**LAND TRANSPORTATION FRANCHISING & REGULATORY BOARD**  
East Avenue, Quezon City

**MEMORANDUM CIRCULAR**  
**NUMBER 2020-007**

**SUBJECT : CLARIFICATION AND AMENDMENT ON MEMORANDUM CIRCULAR NO. 2019-055**

ANNEX A – TOPMOST FRONT WINDSHIELD

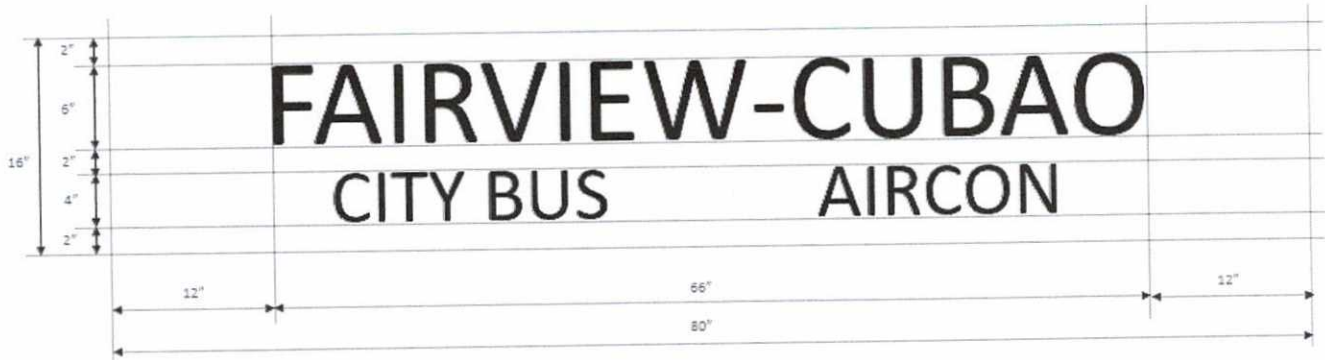
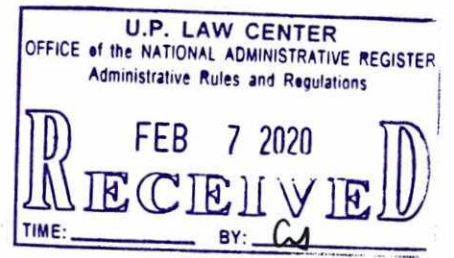
**NOW THEREFORE**, in order to eliminate confusion regarding the markings for provincial and non-EDSA PUB/minibus routes, the Board **RESOLVE** as hereby **RESOLVED** to AMEND item No. 1 of Memorandum Circular No. 2019-055 and the provision on "Bus Classification and Bus Type be removed, and now reads as:

1. At the topmost front windshield: ROUTE

Height	6 inches
Width:	Varies according to letter
Thickness:	3/4 inches

**RESOLVED**, that the sample design for EDSA bus/minibus route attached to MC 2019-055 is hereby modified and the company/trade name be inscribed or printed at the front below the windshield.

**RESOLVED**, further, that the colors on the topmost front windshield is hereby clarified to adopt the following:

Lane A- Yellow Gold  
Lane B- Green  
Lane C- Violet

- Non-EDSA City Bus - Orange
- Provincial Bus From  
South - Blue  
Southwest - Pink  
North- Red
